Amendments to the Drawings:

REMARKS/ARGUMENTS

This is an Amendment and Reply to the Office Action mailed September 30, 2008, in which the following rejections were set forth: Claims 1 and 2 were rejected under 35 U.S.C. § 102(b) as being anticipated by U.S. Patent No. 6,030,215, issued to Ellion et al. ("*Ellion*"); Claims 3-5 were rejected under 35 U.S.C. § 103(a) as being unpatentable over *Ellion*; Claims 6 and 7 were rejected under 35 U.S.C. § 103(a) as being unpatentable over *Ellion* in view of U.S. Patent No. 6,997,883, issued to Hahn ("*Hahn*"); Claims 8 and 9 were rejected under 35 U.S.C. § 103(a) as being unpatentable over *Ellion* in view of U.S. Patent No. 5,295,829, issued to Frey ("*Frey*"); Claims 10, 12, and 13 were rejected under 35 U.S.C. § 103(a) as being unpatentable over *Ellion* in view of U.S. Patent No. 4,17,918, issued to Donohue ("*Donohue*"); Claim 11 was rejected under 35 U.S.C. § 103(a) as being unpatentable over *Ellion* in view *Donohue* and further in view of U.S. Patent No. 5,252,064, issued to Baum ("*Baum*"); and, Claims 14-18 were rejected under 35 U.S.C. § 103(a) as being unpatentable over *Ellion* in view of *Donohue* and further in view of U

Fig. 2

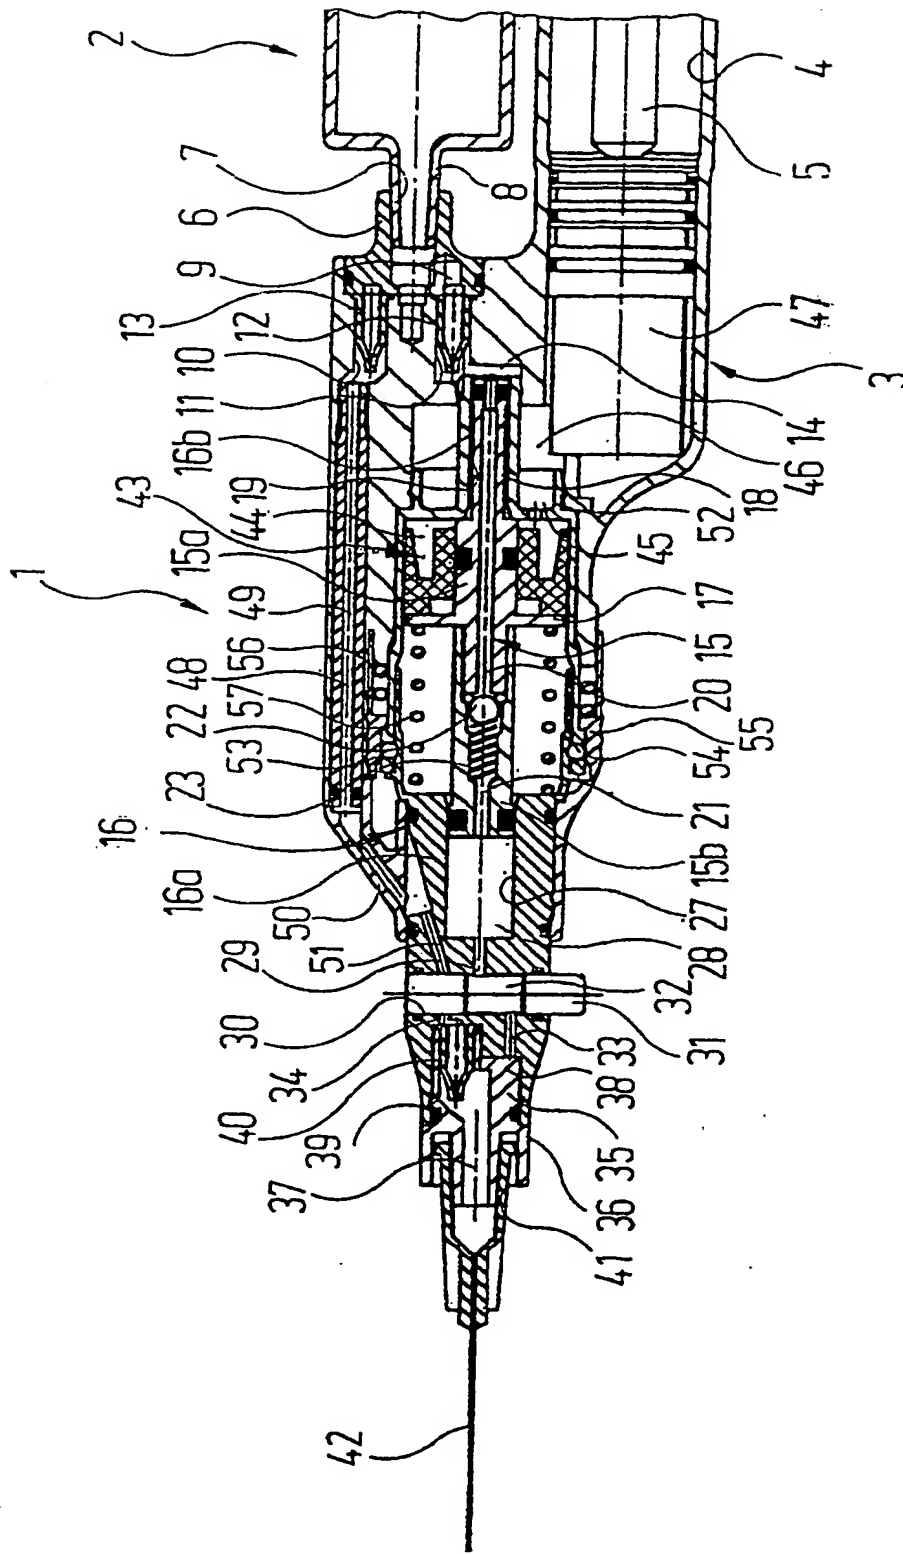
In addition, the Examiner has objected to the drawings as failing to comply with 37 C.F.R. § 1.84(p)(5) because they do not include the following reference signs mentioned in the description: 24 and 16.

With respect to Applicant's contention that the details of Fig. 2 are not clearly illustrated, Applicant does acknowledge that while it may require a certain amount of diligence to follow the reference lines between the reference numerals and the components associated thereto, Applicant respectfully submits that with the appropriate amount of diligence, the drawings and the description thereof provide a detailed and complete representation of the embodiment shown.

The attached sheet of drawings includes changes to Fig. 2. This sheet, which includes Fig. 2, replaces the original sheet including Fig. 2. In Fig. 2, previously omitted reference sign 16 has been added.

With respect to reference signs 16 and 24, Applicant has amended Fig. 2 to include reference sign 16 and the Specification has been amended to include reference sign 24.
